MISSISSIPPI POWER & LIGHT COMPANY

SUBJECT: Grand Gulf Nuclear Station
Units 1 and 2
Docket Nos. 50-416 and 50-417
License No. NPF-13
File: 0260/L-334.0/L-860.0
Purge Valve Operability; License
Condition 1.11 (43)
AECM-82/442

I. General Design Data

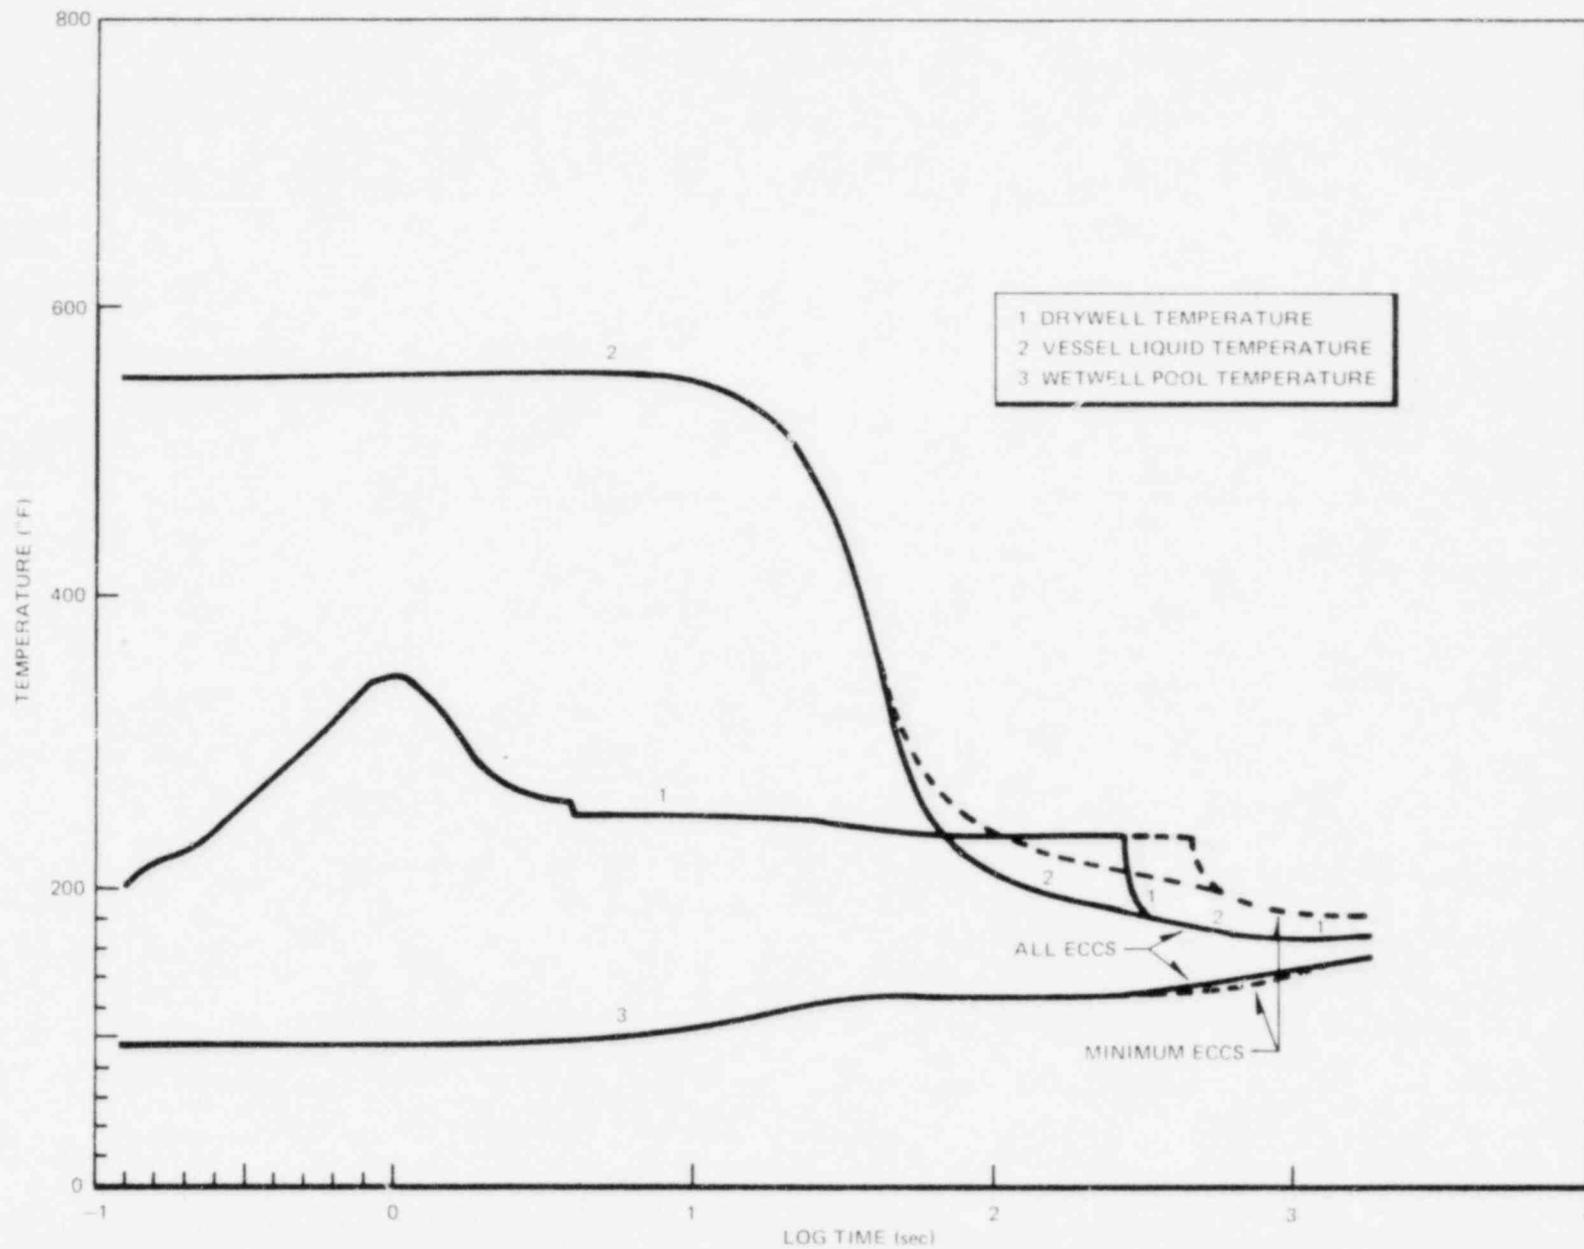
- A. Concern
What is the peak drywell pressure?

- B. Concern
Provide the pressure-time profile of the accident case postulated.

The peak drywell pressure was 22.44 psig (Reference FSAR Figure 6.2-10 and Table 1 of the Pratt Valve Report).

Reference FSAR Figure 6.2-10.

Isometric 1

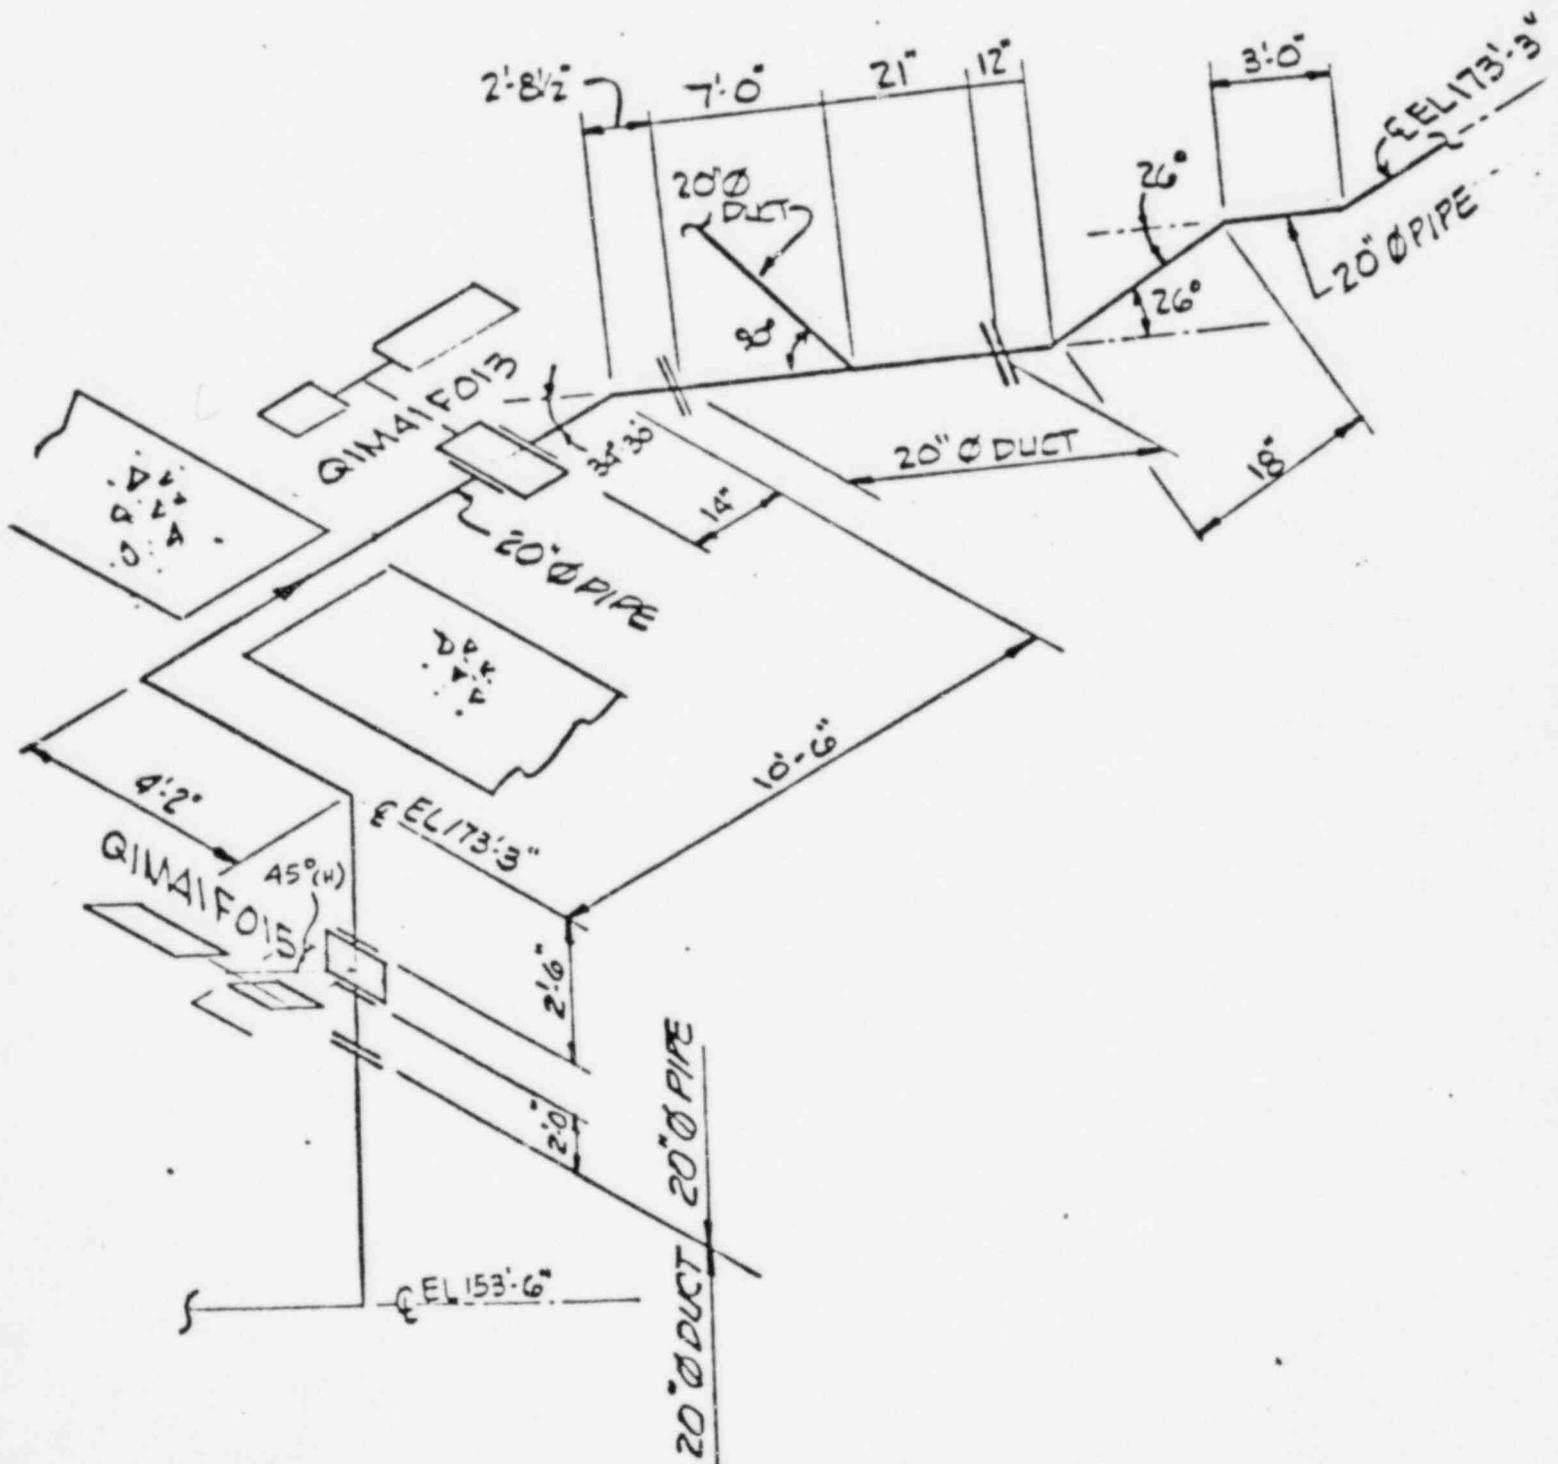
- a. For each purge/vent valve installation provide a sketch or description showing the following:
 - 1) Direction of flow.
 - 2) Disc closure direction.
 - 3) Curved side of valve disc upstream or downstream (asymmetric disc).
 - 4) Orientation and distance of elbows, tees, bends, etc. within 20 pipe diameters upstream of the valve.
 - 5) Shaft orientation.
 - 6) Distance between in-series valves.
- b. Describe the procedures (preferably test) used as a basis to show which installation produces the worst case loads on the valve.
- c. Provide a tabulation of torque coefficients and corresponding inservice valve torques for the installation determined as the worst case for each valve size and type.

Reference drawings M1474, Rev. 25 and M1478, Rev. 14 (copies attached) and Isometrics 1&2 (copies attached).
